Outline Planning Application for Employment Development on Land at Ashford Road, Maidstone

Landscape and Visual Impact Assessment Addendum.

On behalf of Wates Developments Ltd.

Date: 18 May 2023 | Pegasus Ref: P22_1692EN

Appendix 1: Cumulative Screened ZTV Plan

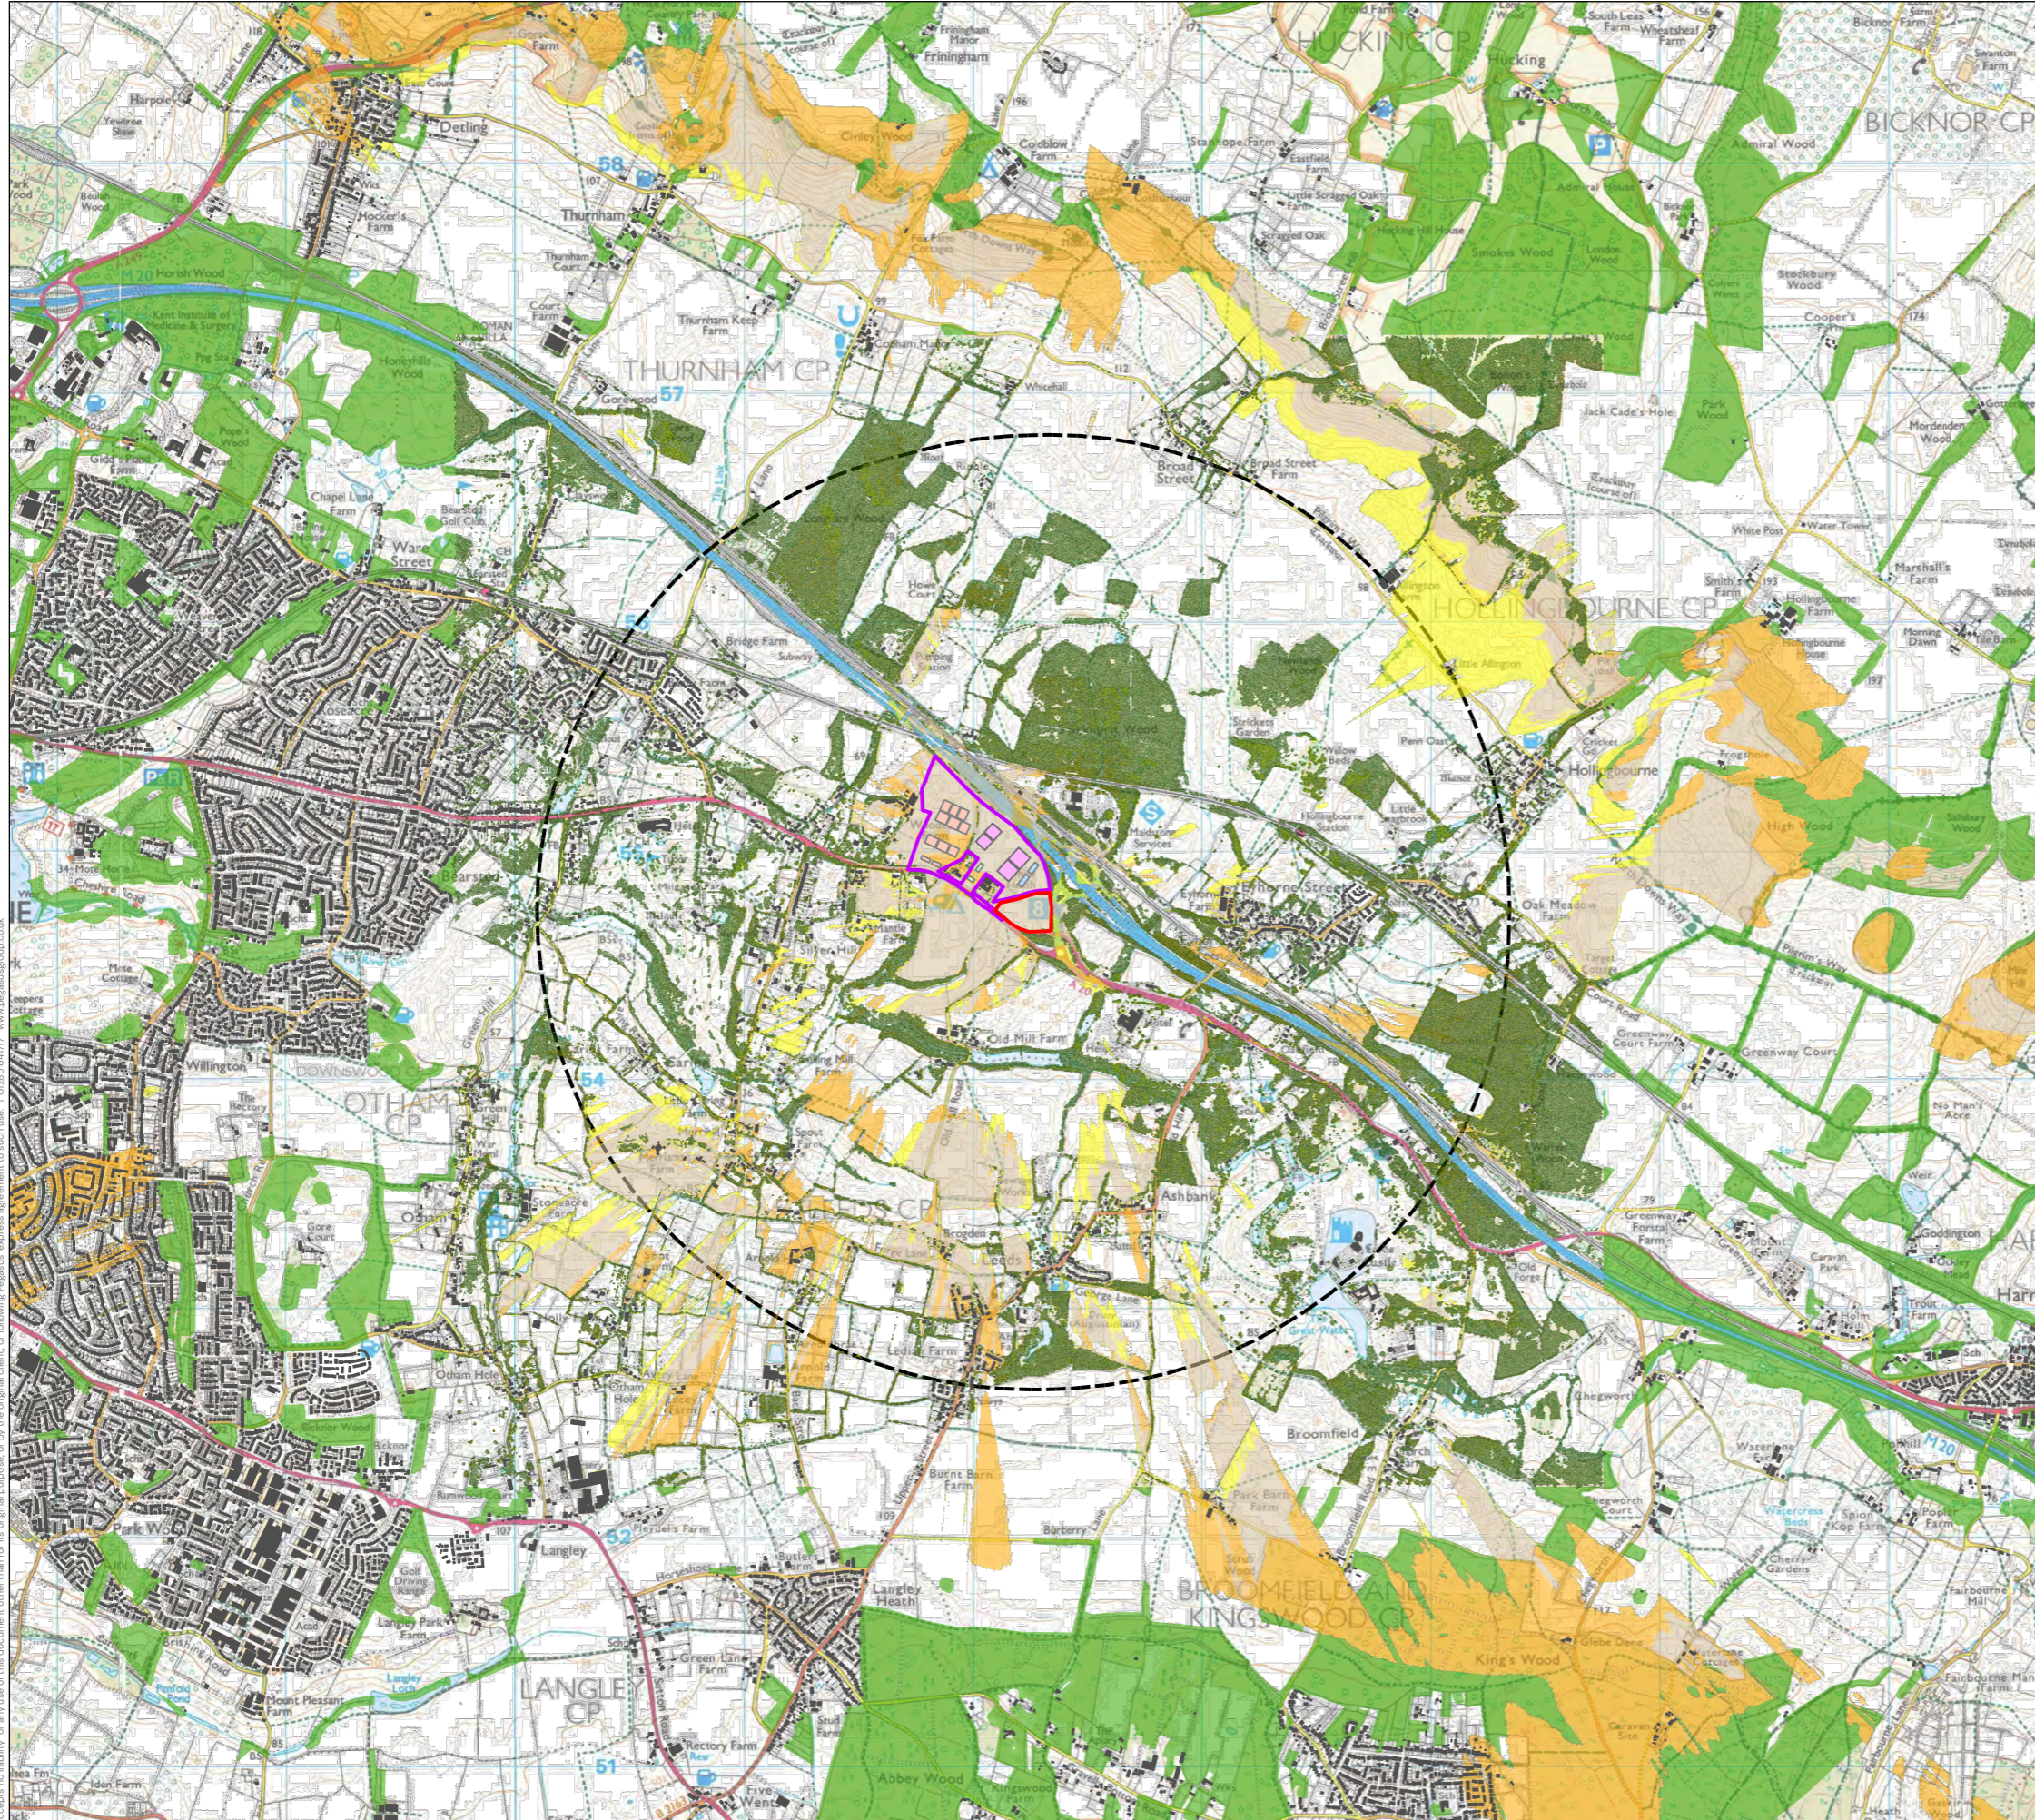
"The MSE note identifies a number of potential deficiencies with the ZTV, relating in particular to its extent, the absence of a "bare earth" version, and the robustness of the data on which it is based. As a result, it is possible that the ZTV has under-represented the potential visibility of the development."

3.3. As noted above for the Proposed Development a computer modelled SZTV refined through field evaluation has informed the assessment of visual effects. Whilst technical comments from MS Environmental² are noted it is considered that the SZTV Plan prepared to support the LVIA is robust. For the avoidance of doubt a ZTV and Screened ZTV Methodology is included at **Appendix 4**.

Appendix 3: Updated Photomontages

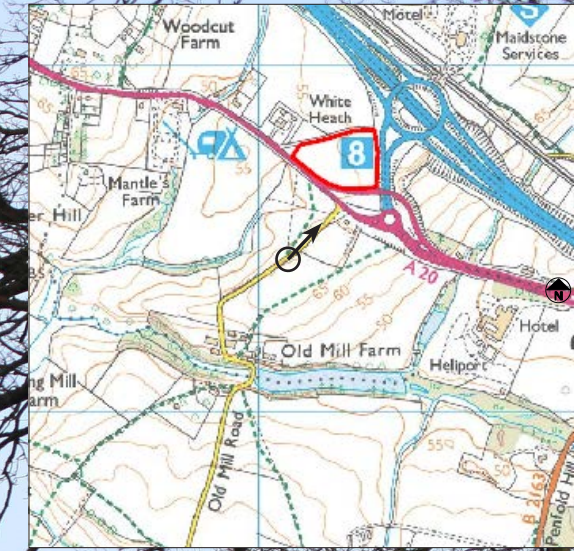
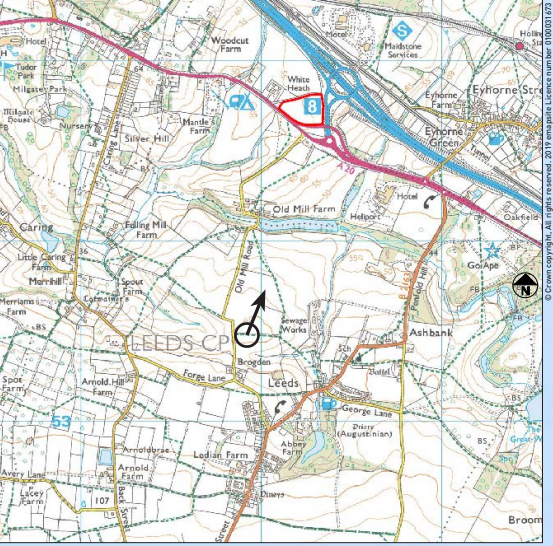
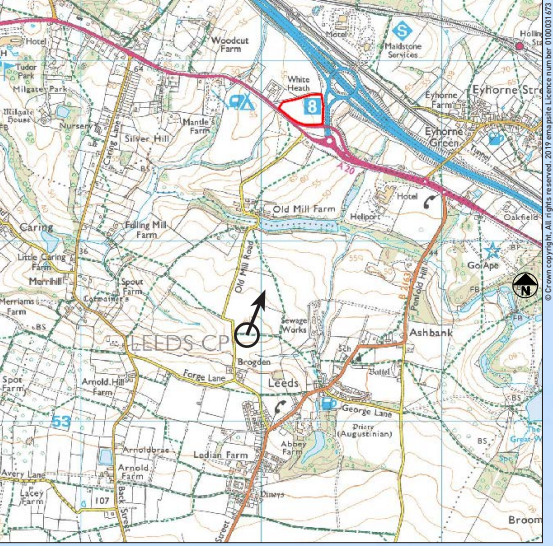
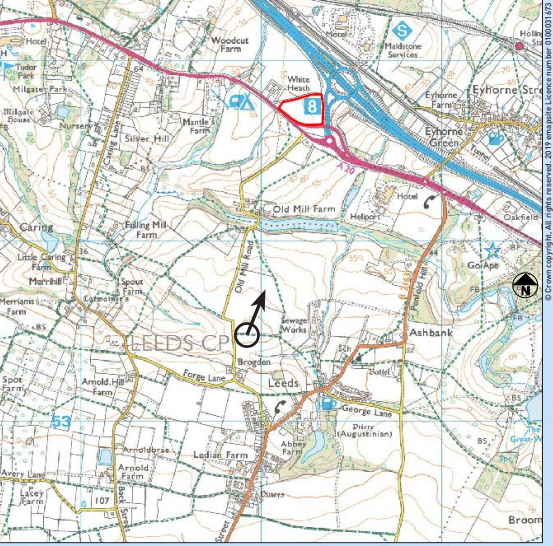
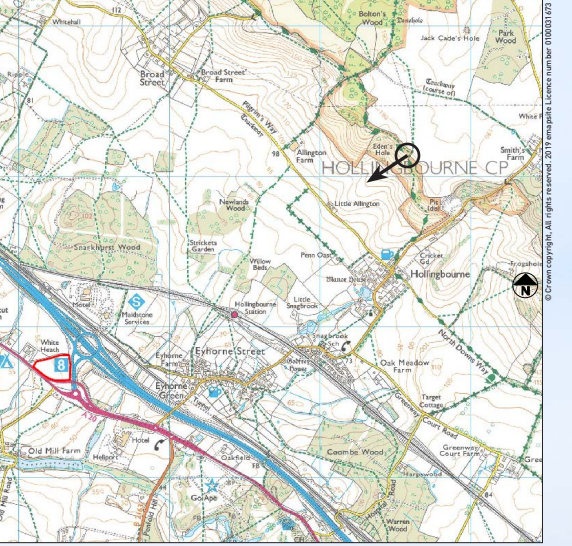
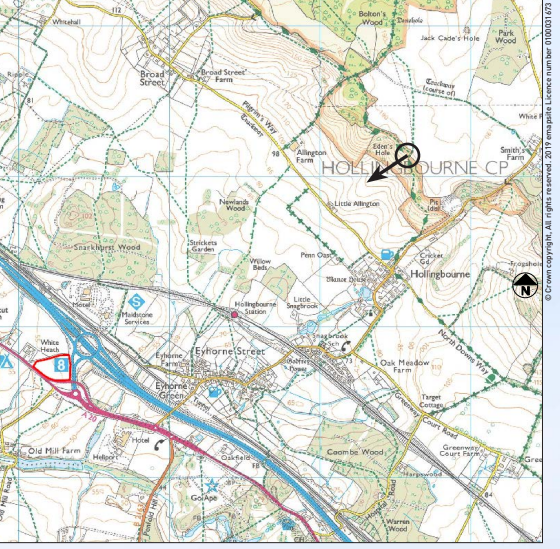
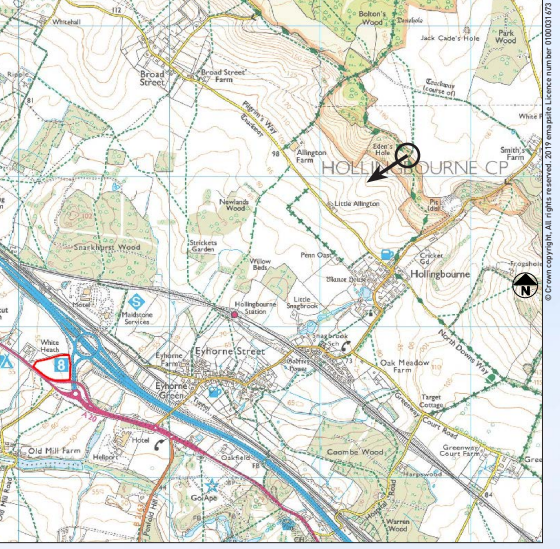
“The LVIA includes photomontages of the proposal, including from a Viewpoint within the Kent Downs, VP12. There appears to be a significant error in that from VP 12, the site location is shown is a wholly

incorrect location, both in respect of the annotated red line indicating the location of the site and in respect of the photomontages, which indicates the site and building shown some significant distance away from the correct location (it appears to be placed to the south west of Woodcut Farm, rather than correctly to the east of the employment development)."

“Three of the viewpoints (6, 10 and 12) have been used for the preparation of photomontages. Whilst these appear to be broadly representative of short-, medium- and longer-distance views respectively, this amounts to a relatively small sample – something like double this number would have provided a more rounded understanding of the potential impact of the development. In view of the MSE comments on viewpoint selection, it cannot be confirmed that the modelled views are sufficiently representative of the most relevant impacts of the development.

- 2.6. It is acknowledged that an error occurred in the preparation of the Photomontage for Viewpoint 12 submitted with the application. Subsequently all the Photomontages submitted with the application have been reviewed for accuracy and have been updated using the methodology included at **Appendix 2**. This methodology is compliant with LI TGN 06/19 and has been tested and endorsed by Planning Inspectors at numerous appeals. It is therefore considered to be robust. The updated Photomontages are included at **Appendix 3**.

- 3.6. Three Photomontages were considered sufficient to assess the effects in relation to the key viewpoints identified. As noted above during the determination period an attempt was made to agree the final number of visualisations required, however no response was received from the Council following the email sent on the 3rd April 2023.
- 3.7. As noted above, it is acknowledged that an error occurred in the preparation of the Photomontage for Viewpoint 12 submitted with the application. Subsequently all the Photomontages submitted with the application have been reviewed for accuracy and have been updated using the methodology included at **Appendix 2**. This methodology is compliant with LI TGN 06/19 and has been tested and endorsed by Planning Inspectors at numerous appeals. It is therefore considered to be robust. The updated Photomontages are included at **Appendix 3**.
